BOSTON EDISON COMPANY
300 BOYLSTON STREET
BOSTON, MASSACHUSETTS 02199

June 28, 1984
BECO. 84-095

License No. DPR-35
Docket No. 50-293

On May 2, 1984, a telephone conference took place regarding the Pilgrim Nuclear Power Station Inservice Inspection Program. Participants at this meeting were P. Leech from the NRC; G. Freund and R. Yorg from EG&G; and F. Famulari, T. Ferris, and M. Williams from Boston Edison Company. Eleven items were discussed, in which resolution was reached on NRC Items 1, 2, and 3. This letter provides information for resolution of the remaining items (4-11).

Attachment 1

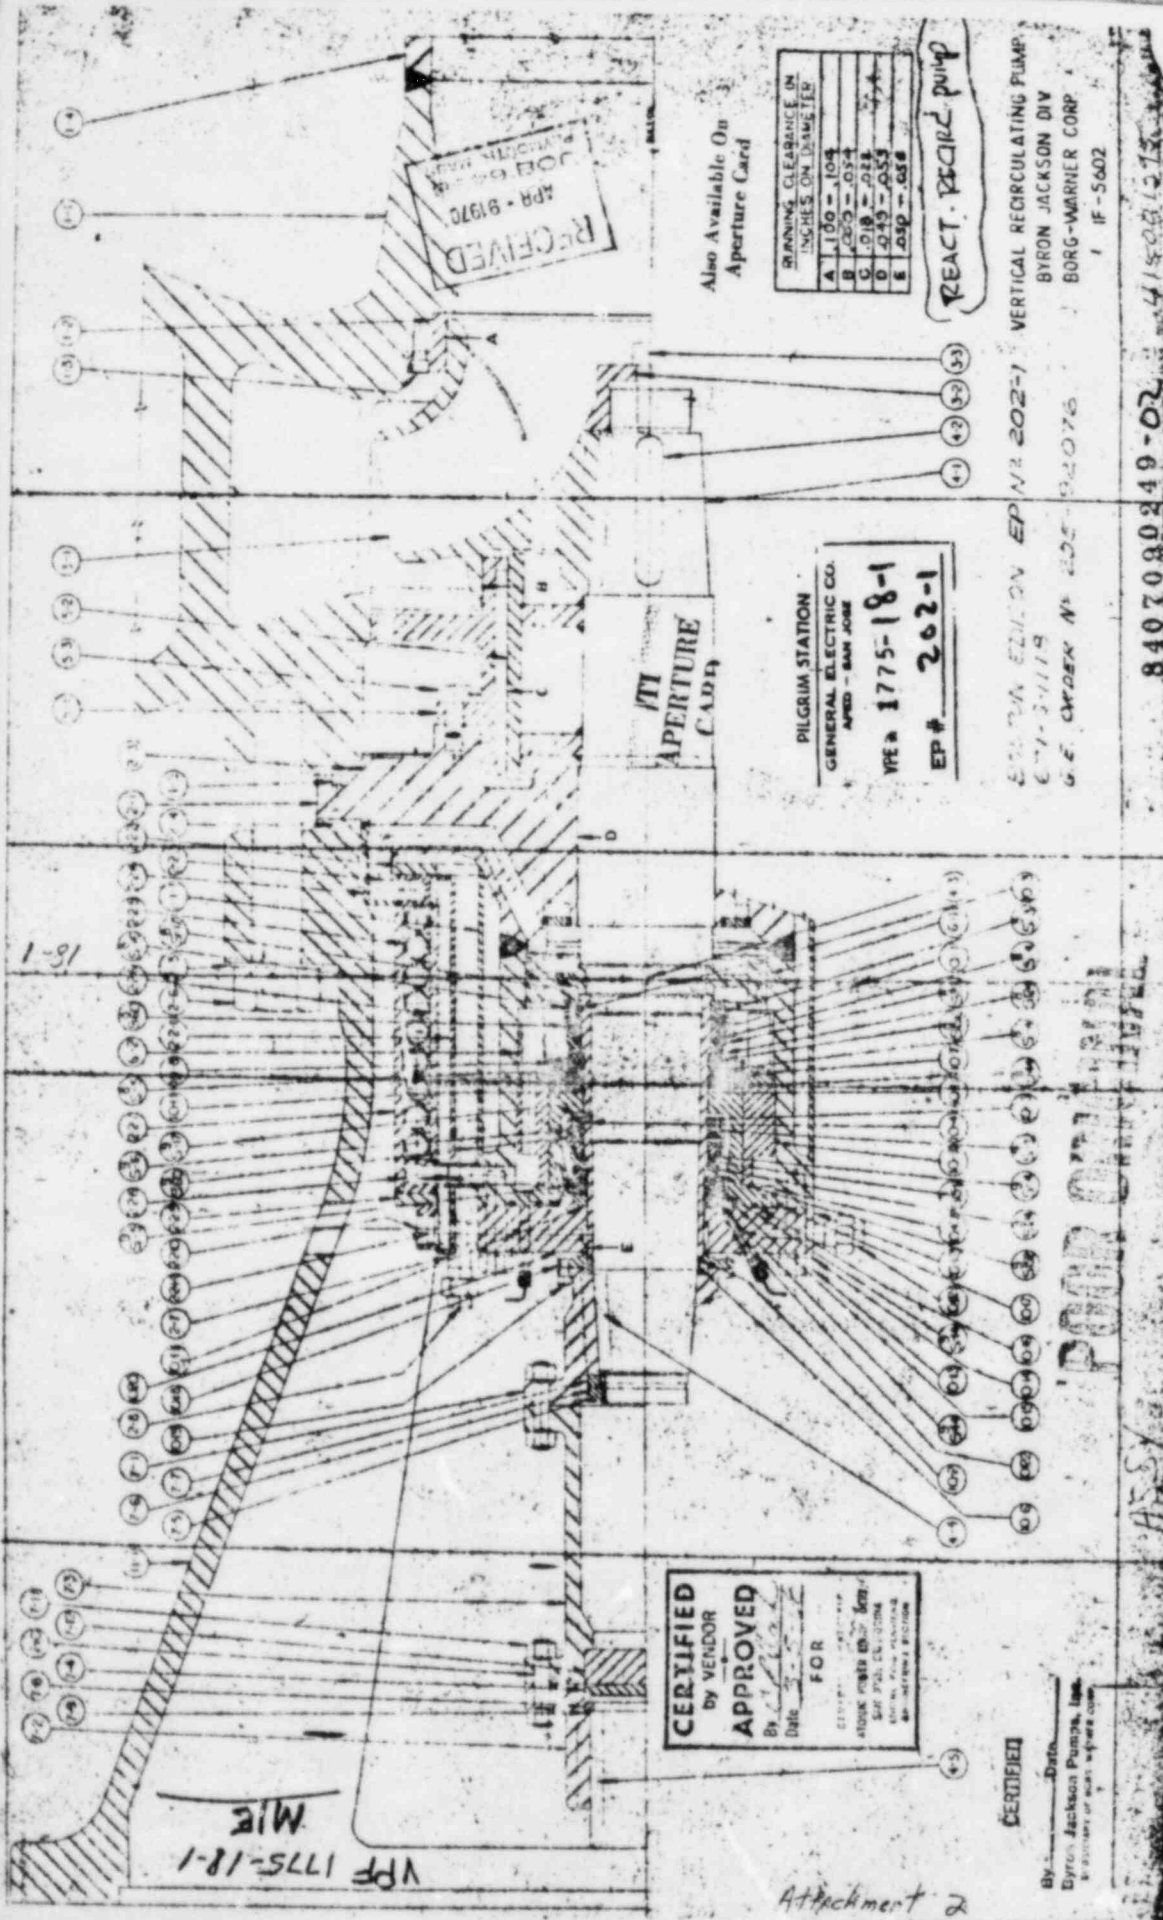
Your letter to NRC (answer to NRC Question #2, BECo , #82-296, dated 11/15/84) mentioned that none of the welds in the recirculation pump casing were pressure-retaining. Please provide cross-section drawings of your pumps that show the casing welds.

The requested reactor recirculation pump cross-section drawings are provided as Attachments 1 and 2 to this letter.

E-232-336

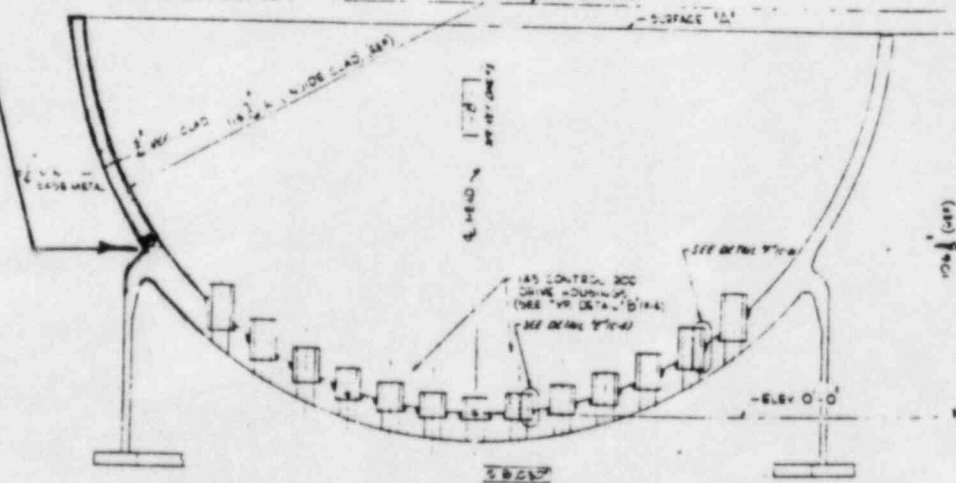
Item B1.21 and B1.22 of Category B-A (PRR-5) require that the accessible portions up to 100% of one head weld in each direction be examined. It appears that your program meets code requirements for examining head welds. Please state why you believe that relief is needed.

The reactor vessel bottom head meridional welds are accessible for ultrasonic examination. However, the configuration of the reactor vessel bottom head and vessel support skirt limits the examination of the outer circumferential weld to a one side only examination. See Attachments 5 and 6 for drawings depicting the accessible welds and the restrictions. Approximately sixty percent of the length of the reactor vessel bottom head welds is accessible for examination. Revised Relief Request No. PRR-5 is submitted as Attachment 7.

WE CAN ONLY PERFORM A ONE SIDED EXAM DUE TO THE VESSEL SKIRT
